NL150007

Re: Huntlee Residential Subdivision (MOD16) - Response to Engeny Peer Review

Northrop Consulting Engineers have prepared the following response to the Engeny Water Management (Engeny) peer review dated the 30 August 2021 and received from DPIE on the 23 September 2021. The following provides additional information requested by Engeny. This letter should be read in conjunction with the following documents:

Figure 1 - Australian Rainfall and Runoff 2019 Hazard Categories

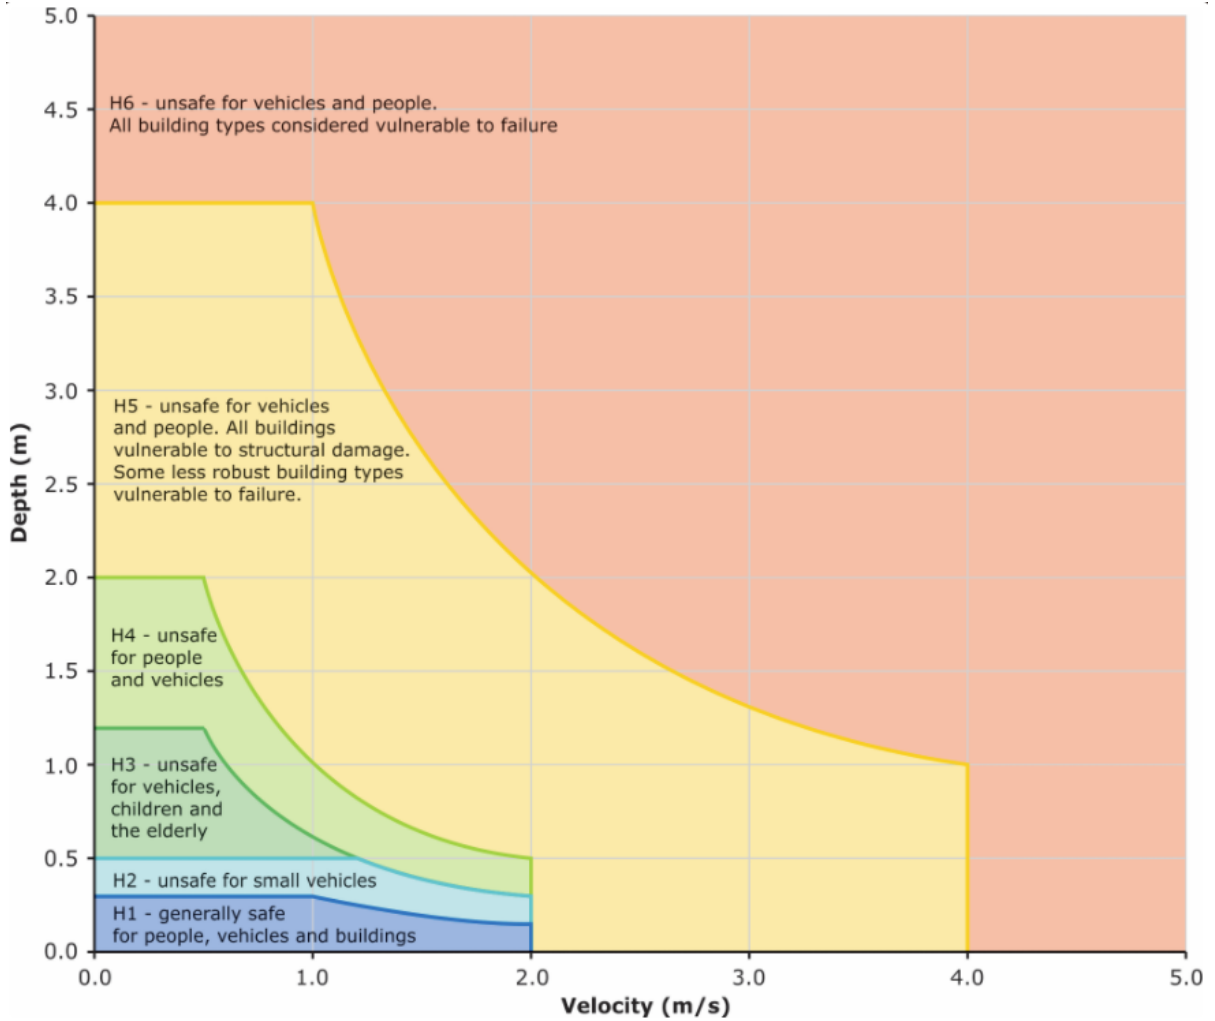
What the inundation depths are at the edge of the building envelopes for Stage 11 lots within the modelled PMF inundation extent, including consideration of the evacuation requirements for the lot in the north-east of Stage 11.

A maximum PMF flood level of approximately 47.13m AHD has been modelled in the existing detention basin. Minimum terrain levels in Tooze Circuit, adjacent to Stage 11, and the affected lots is approximately 46.95m AHD. This corresponds to a maximum flood depth of 180mm in Tooze Circuit with very minor flooding expected in the adjacent lots. Similarly, flow velocities in the area are expected to be low as flows will be arrested and detained by the downstream basin embankment.

The following Figure 1 presents the latest Australian Rainfall and Runoff 2019 hazard categories. With a flood depth less than 300mm and low flow velocities expected, H1 hazard conditions are expected in Tooze Circuit and within a small portion of the adjacent residential lots during the PMF. This flow behaviour is safe for both vehicles and pedestrians and as such, evacuation from the affected lots is still available.

Attachment 1

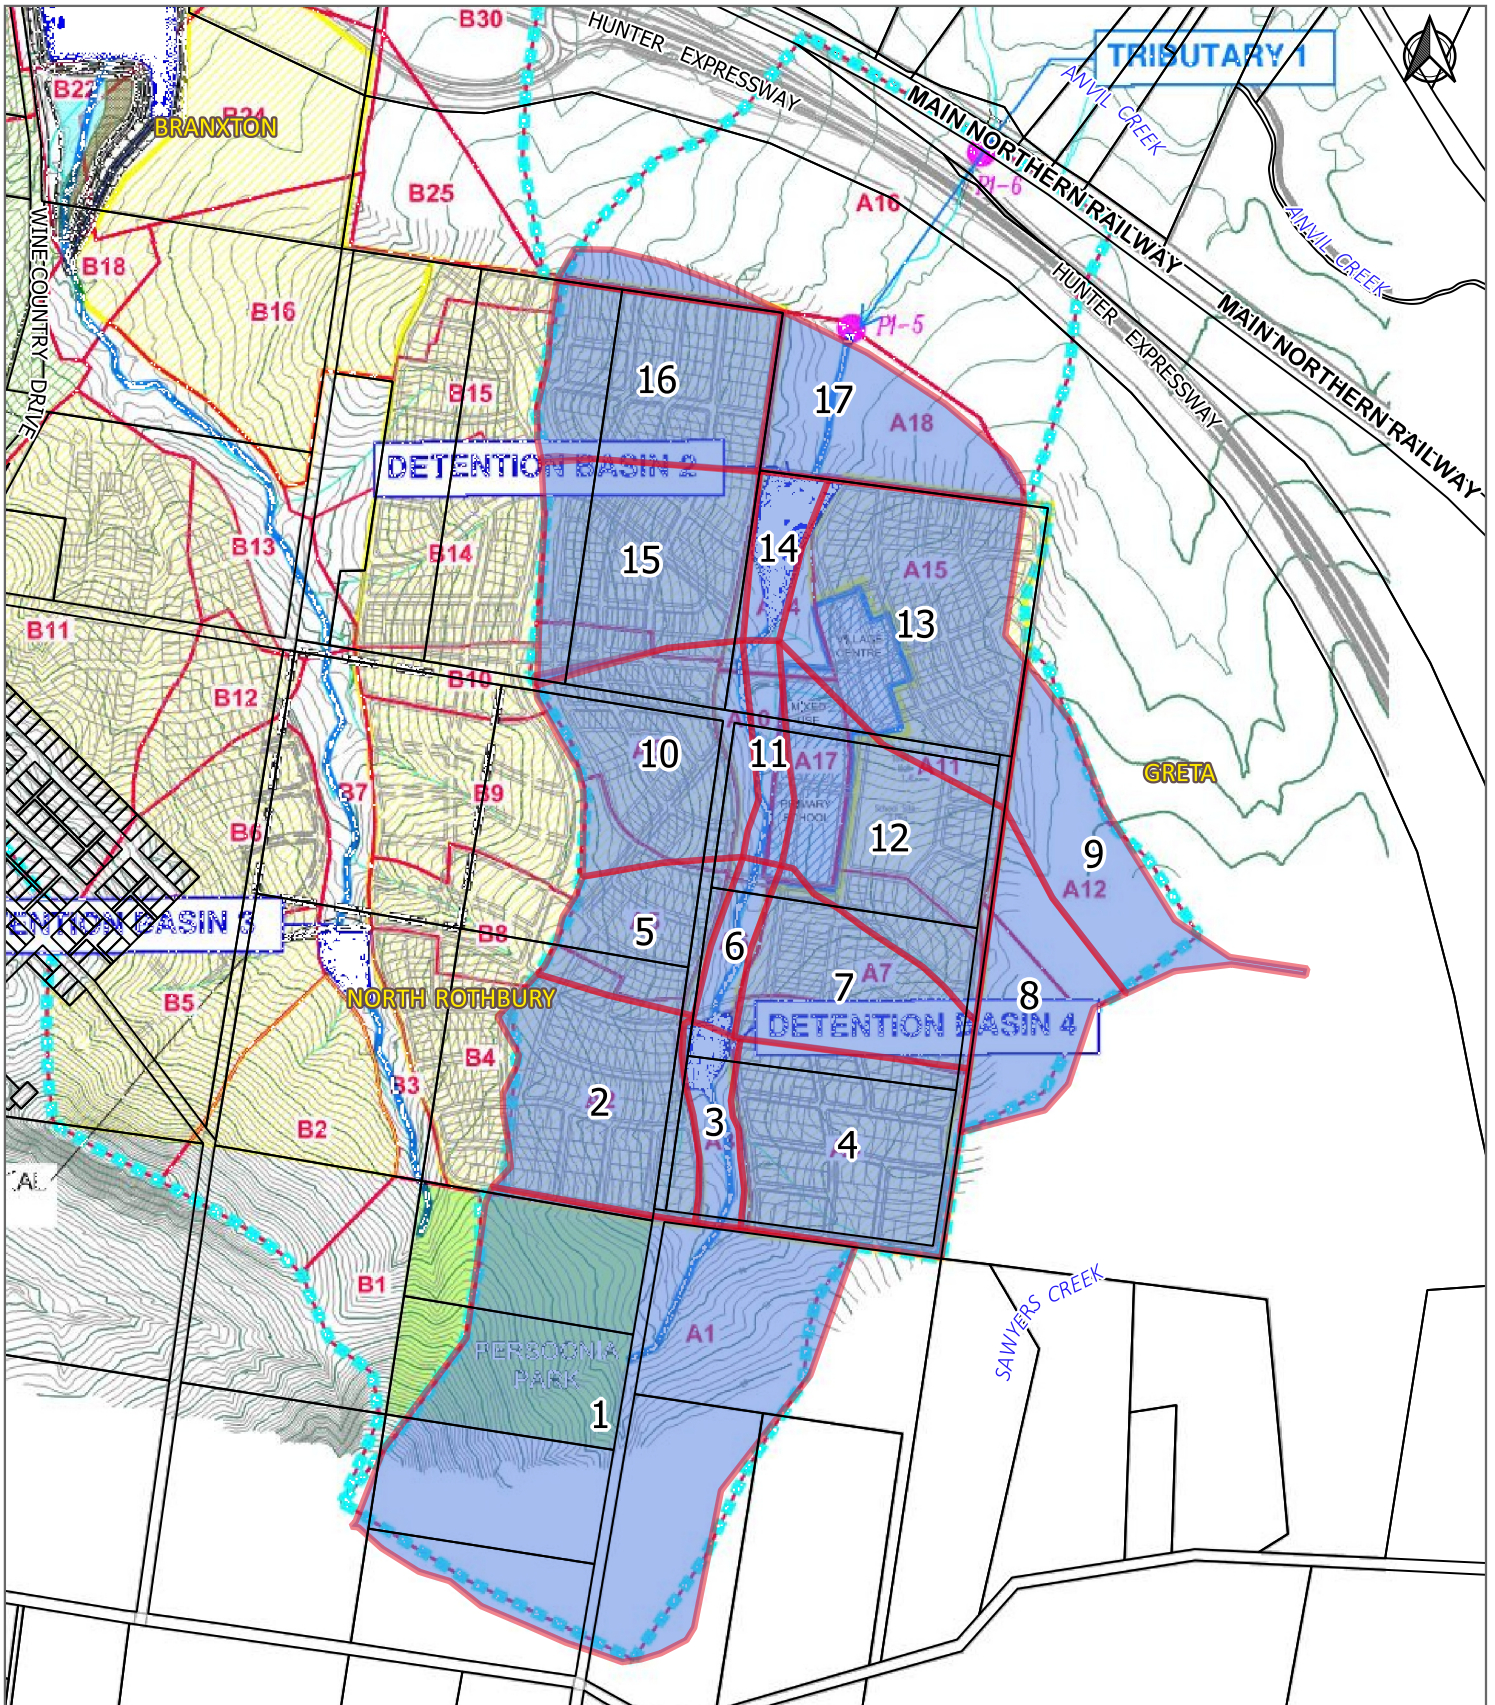
List and discuss the difference between the modelling parameters used by Worley and Northrop specifically addressing:

Model Extent:

Attachment 1, shows the difference in model extents between the Worley and Northrop Study Developed Case Catchments. The model extents have only very minor differences, expected to be due to slightly different delineation of hill crests, potentially due to the quality of terrain data available at the time of preparation.

The largest difference is observed in the catchment between the subject site and rail corridor, downstream of the subject site. With pre-to-post modelling originally analysed at the site boundary by the Northrop Study, this additional catchment was not required. This catchment has subsequently been incorporated into the June 2021 issue of the Northrop Study in order to review the peak flows at the rail corridor.

Attachment 2

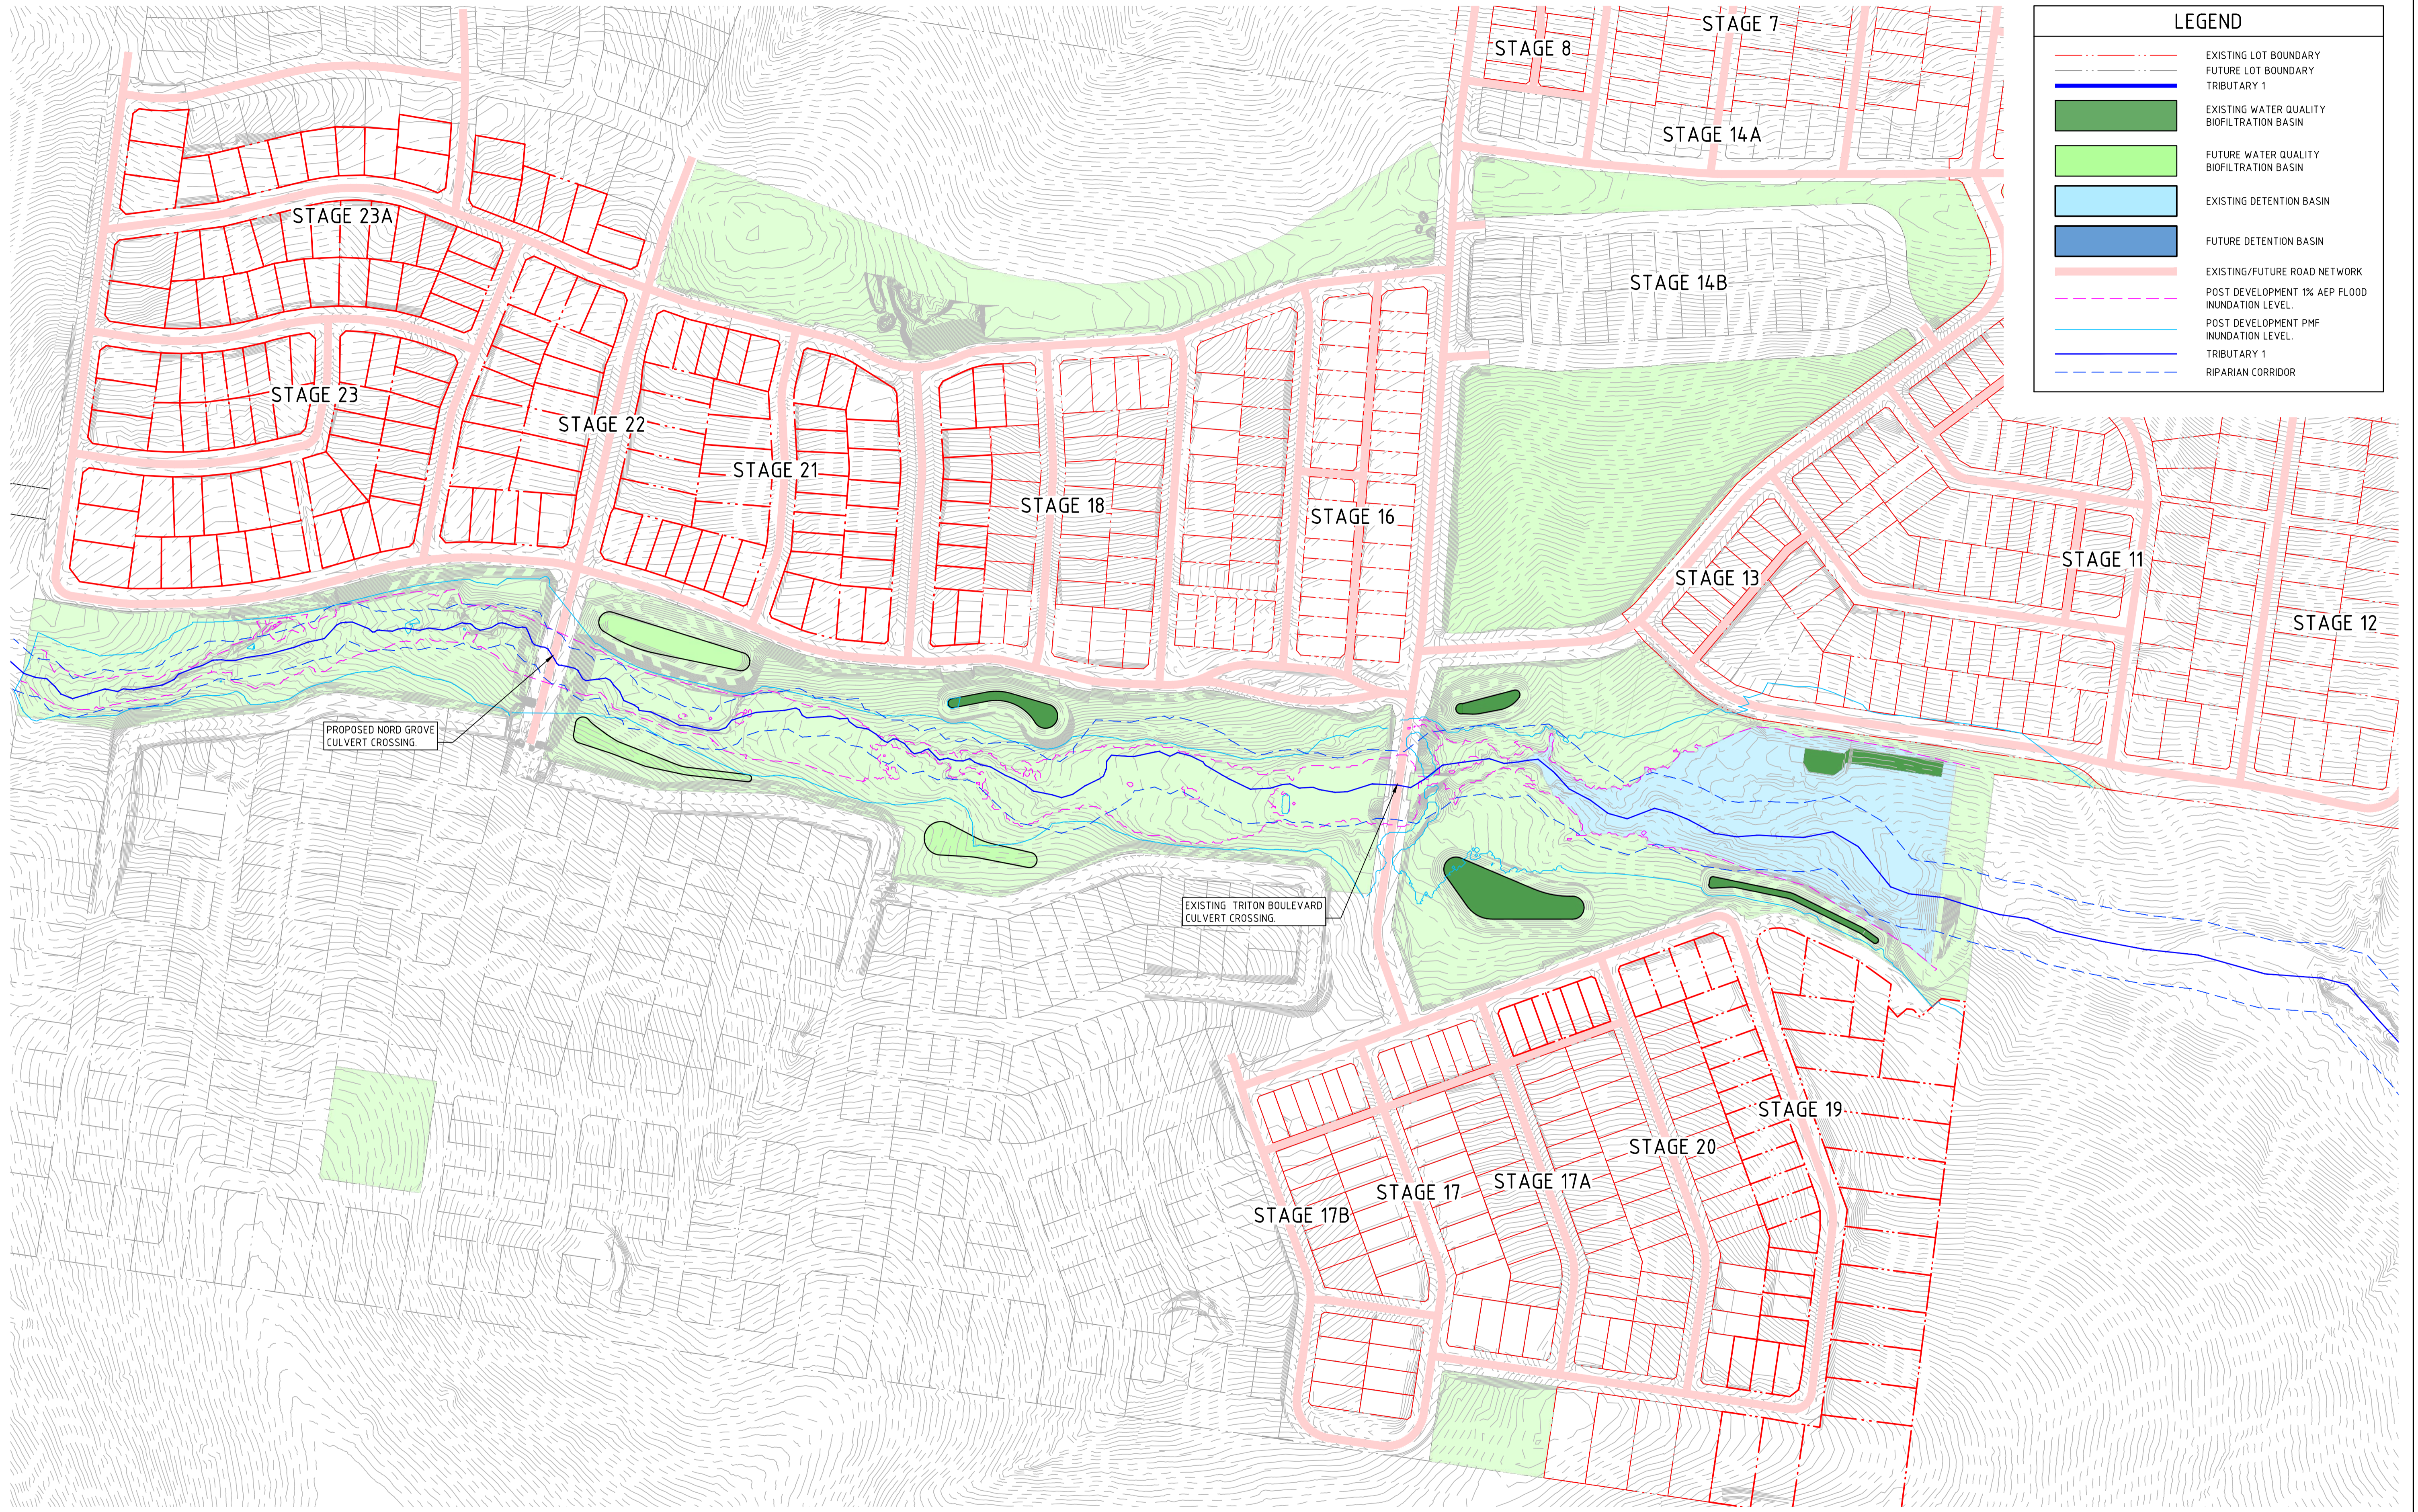
Details the area of riparian zones with non-riparian corridor works within them, and a plan showing where these will be offset.

Attachment 2 illustrates Tributary 1, the extreme flood lines, the riparian buffers and subdivision footprint. The subdivision footprint is shown to be clear of the riparian buffers, except for the watercourse crossings. The watercourse crossings are required for access and do not generally need to be offset within riparian buffers.

A Vegetation Management Plan (VMP) for Tributary 1 has been prepared and accepted by NRAR. Once subdivision works are complete the VMP will be implemented to restore the riparian corridor.

The only known works that may impede into riparian corridors are stormwater outlets and rec tracks which will ultimately be positioned around vegetation. Both of these items are permissible within riparian corridors and do not require specific offset areas.
